Tice River Homes Legacy

client
Tice River Homes

project
Legacy

model
40-02

BASEMENT FLOOR ELEV 'A' & 'B'

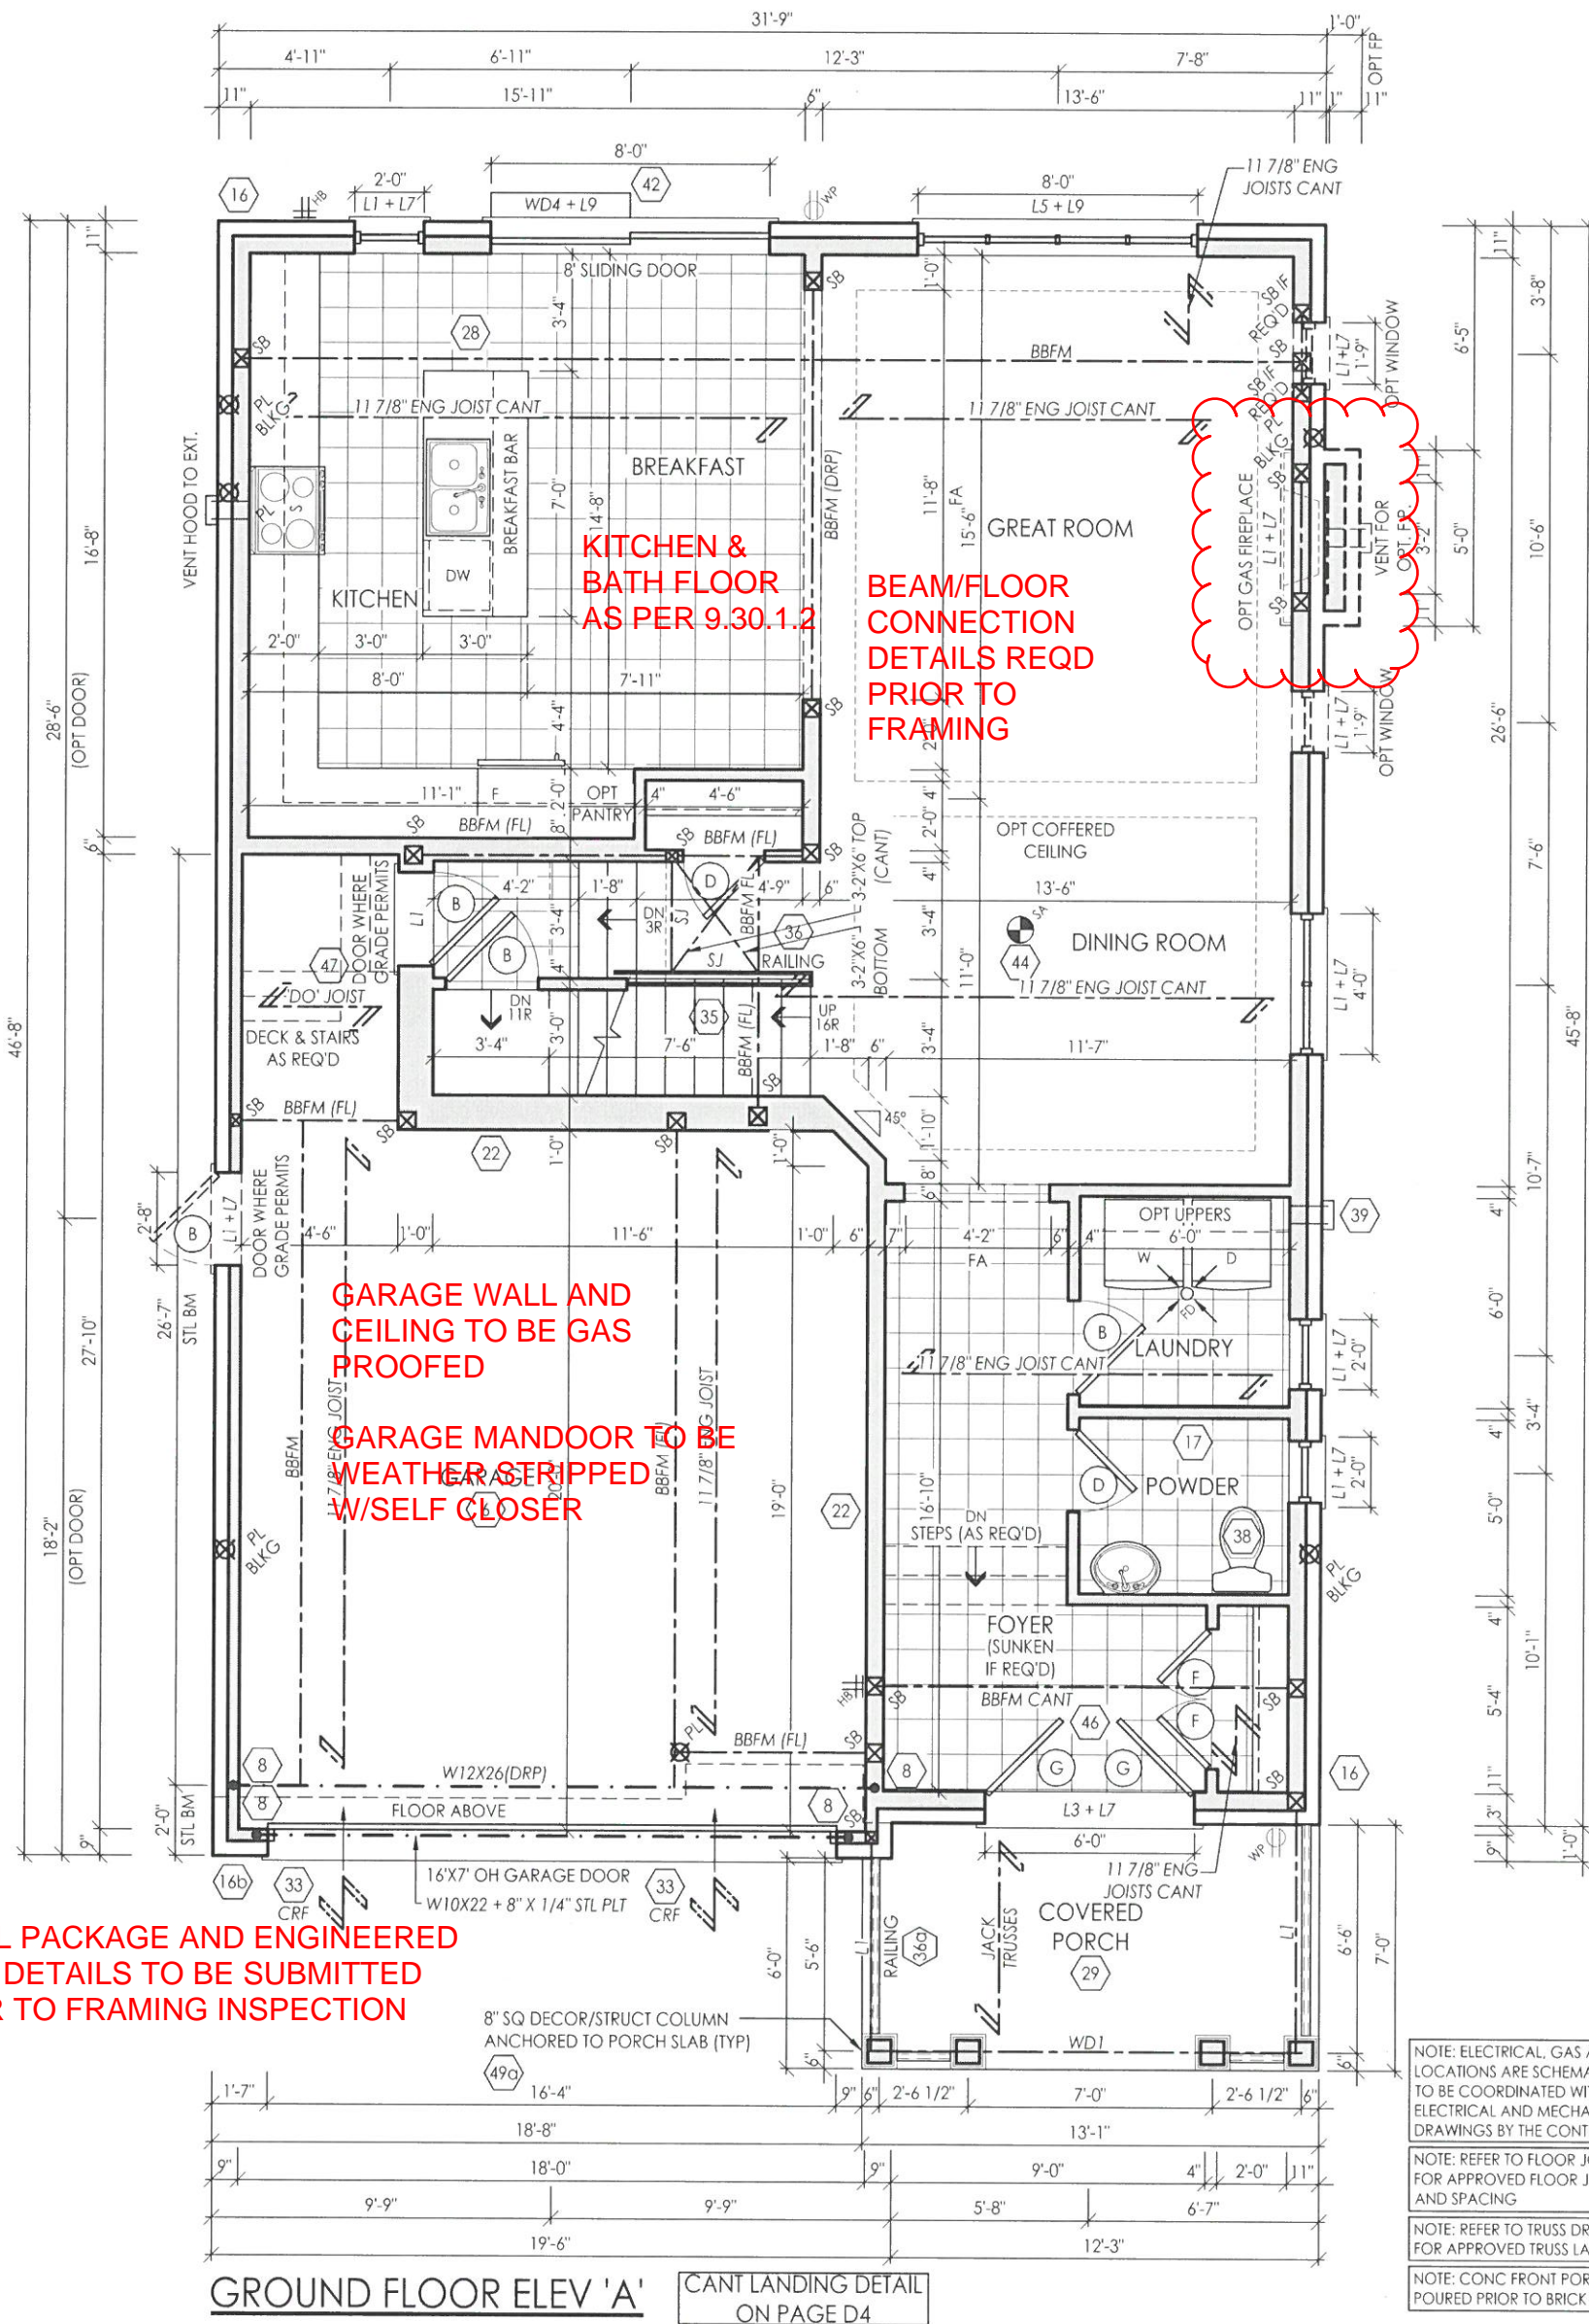
**BASEMENT AIR BARRIER
SUMP LIDS, JOINTS AT INTERSECTIONS AND ALL
PENETRATIONS OF SLAB MUST BE SEALED TO
PREVENT AIR LEAKAGE**

**FUTURE DWGS TO
HAVE BEAM SIZED
NOTED ON PLANS**

**ALL BEAM DETAILS TO BE SUBMITTED TO
TOWNSHIP PRIOR TO FRAMING**

GROUND FLOOR ELEV 'A' CANT LANDING DETAIL ON PAGE D4

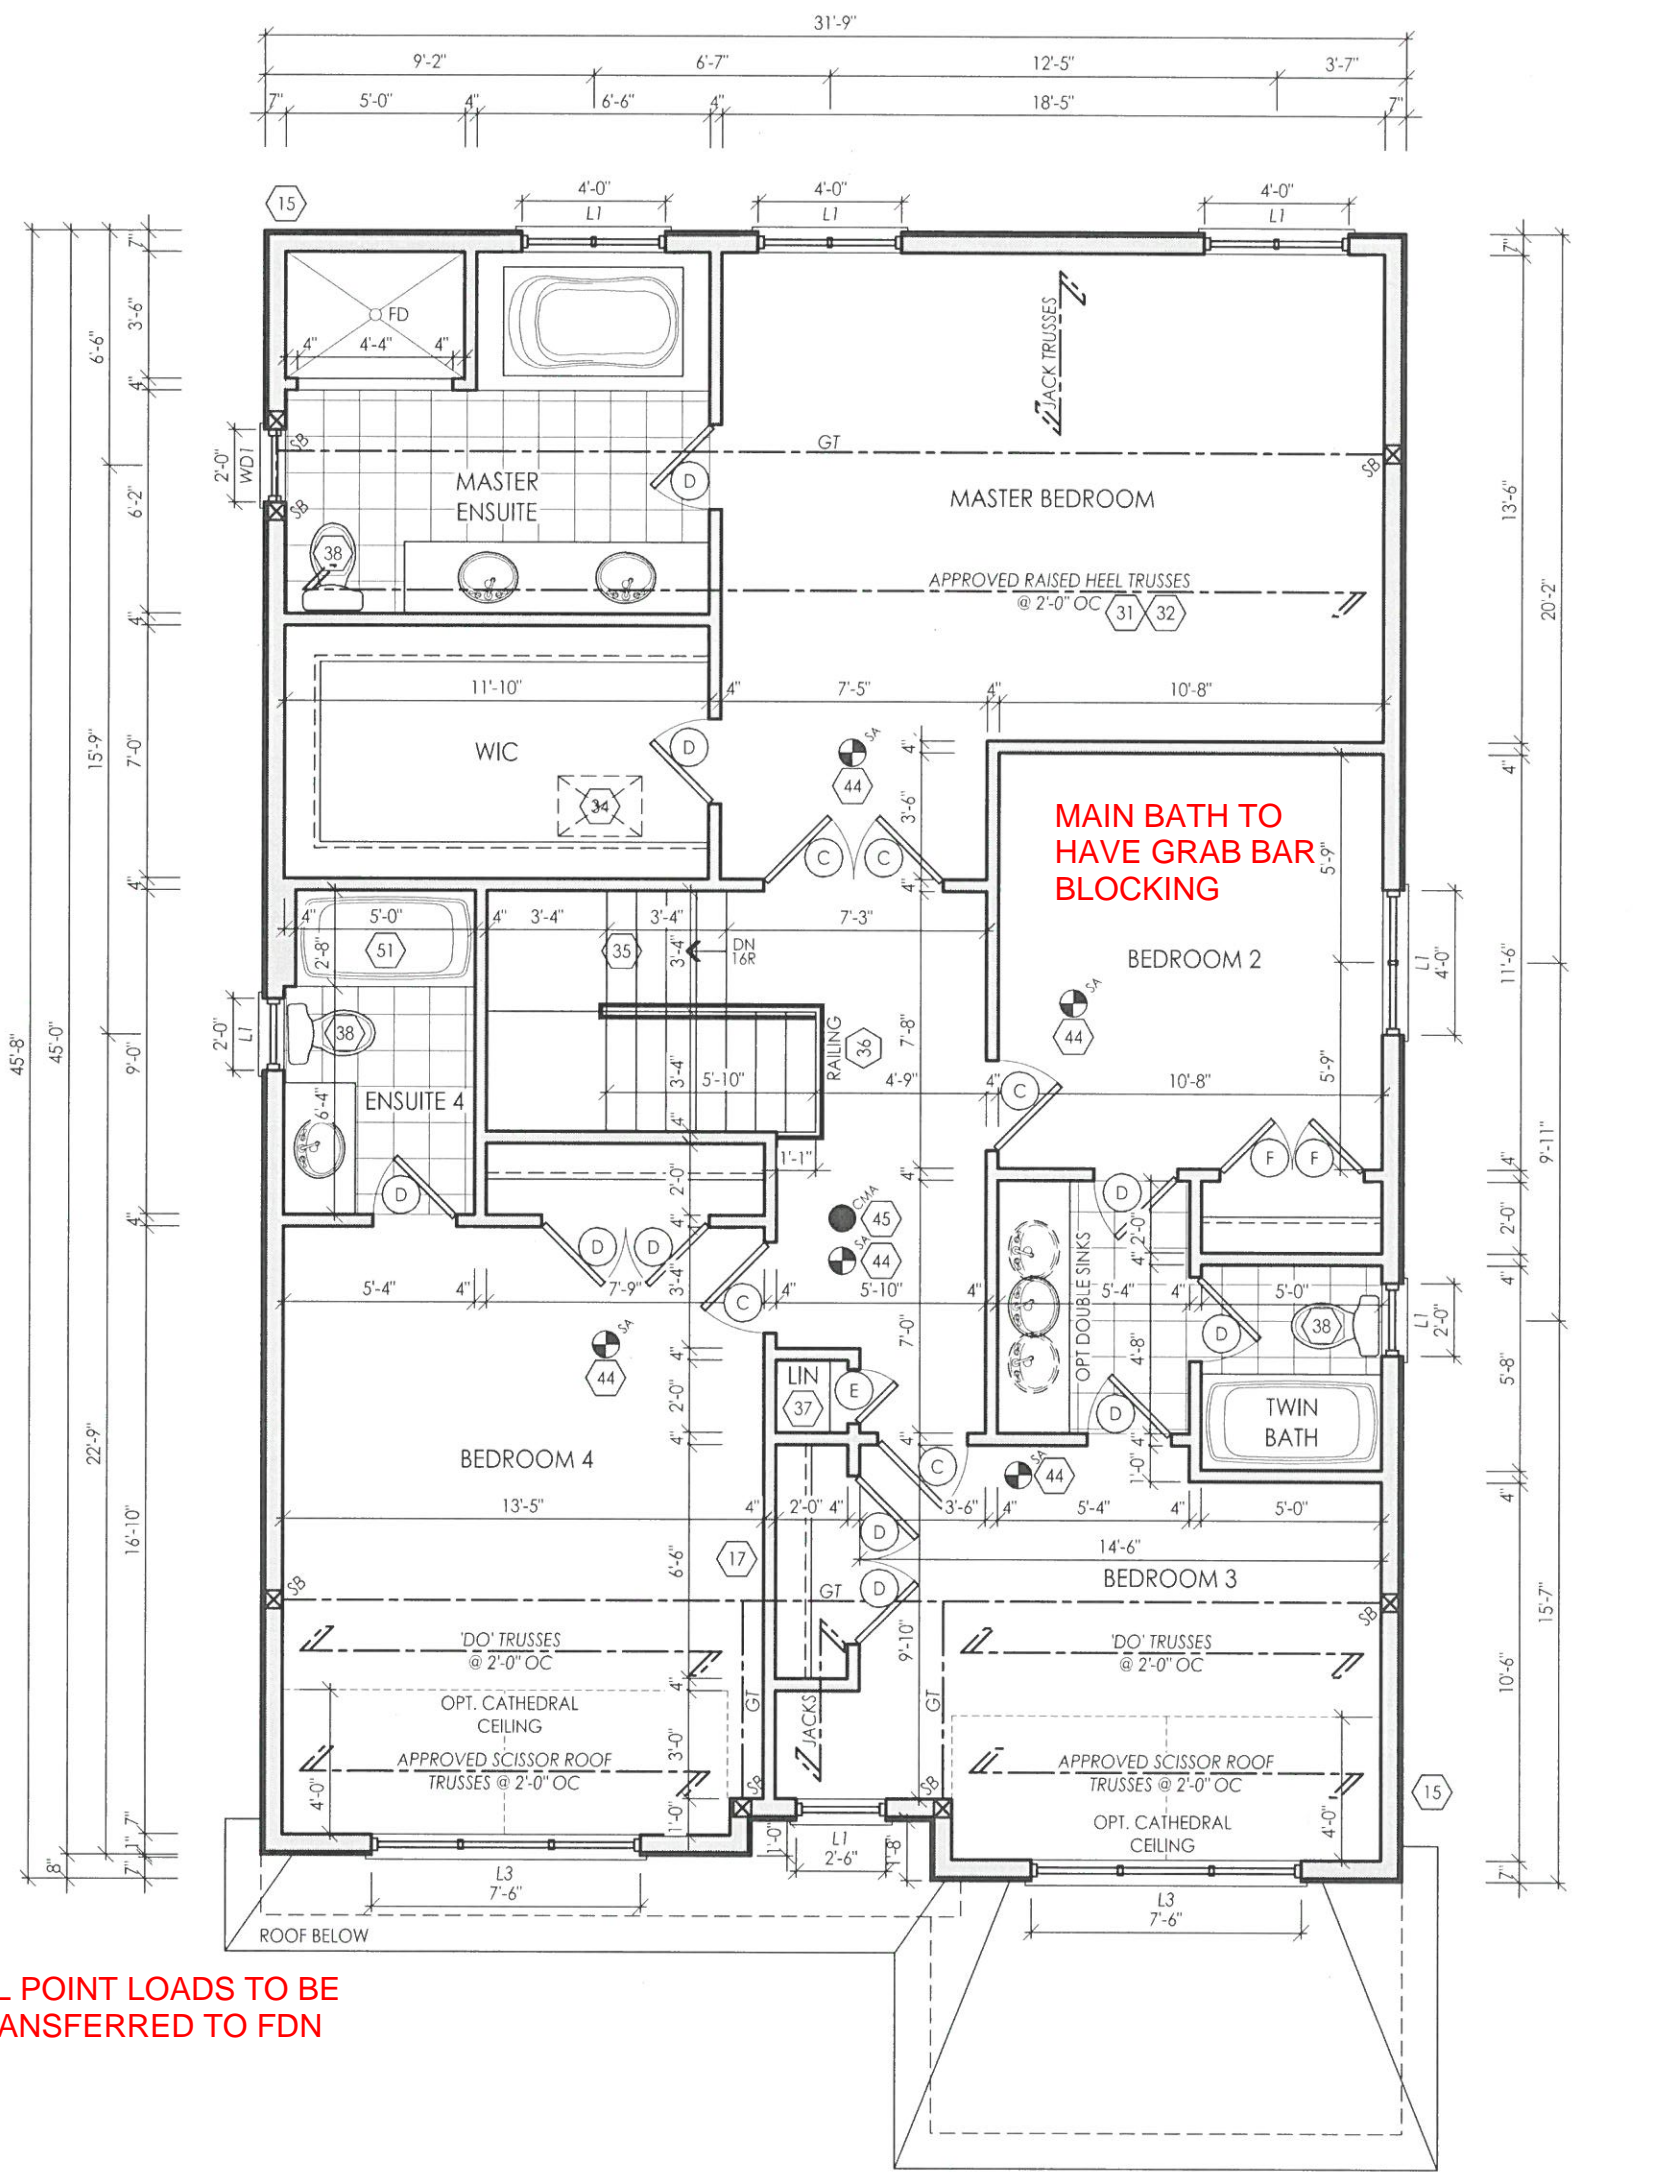
LINTEL PACKAGE AND ENGINEERED BEAM DETAILS TO BE SUBMITTED PRIOR TO FRAMING INSPECTION

GARAGE WALL AND CEILING TO BE GAS PROOFED
GARAGE MANDOOR TO BE WEATHER STRIPPED W/SELF CLOSER

BEAM/FLOOR CONNECTION DETAILS REQD PRIOR TO FRAMING

KITCHEN & BATH FLOOR AS PER 9.30.1.2

ALL FUTURE SUBMISSIONS REQUIRE BEAM AND LINTELS SIZES TO BE NOTED ON DRAWINGS.

SECOND FLOOR ELEV 'A'

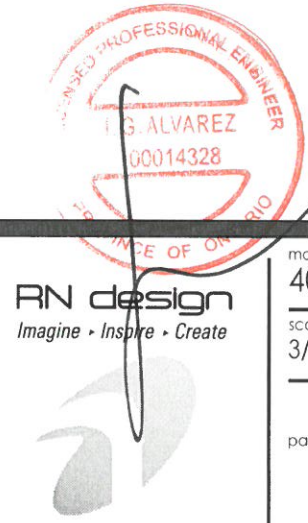
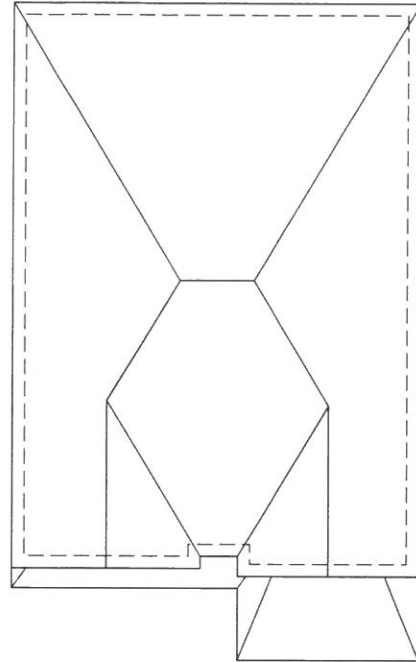
ENGINEERED FLOOR LAYOUT, TRUSSES, BEAMS AND LINTELS TO BE SUBMITTED PRIOR TO FRAMING. DESIGNER TO COMPLETE RESPONSIBILITY REVIEW FORM DN TO BE SUBMITTED WITH FRAMING PACKAGE.

ALL POINT LOADS TO BE TRANSFERRED TO FDN
